SUNDRY NOTICES AND REPORTS ON WELLS

Plug And Abandonment Procedure

Cato San Andres #559

Chaves County, NM / API 30-005-28011

Proposed Wellbore Diagram

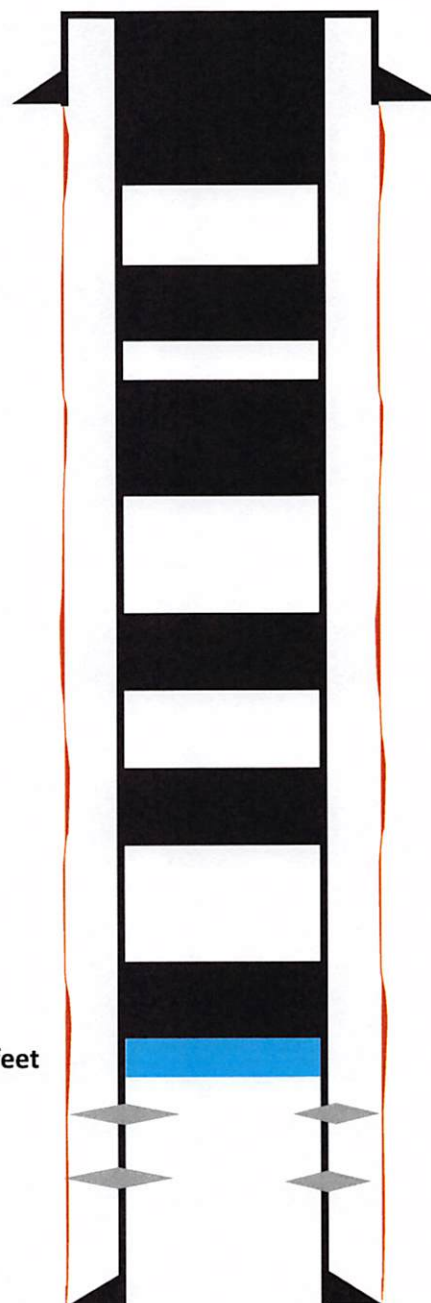
APPROVED WITH CONDITIONS

Perf & Sqz all csg shoes.
Perf & Sqz all plugs w/ no cmt behind pipe.
Adhere to NMOCD COAs attached.
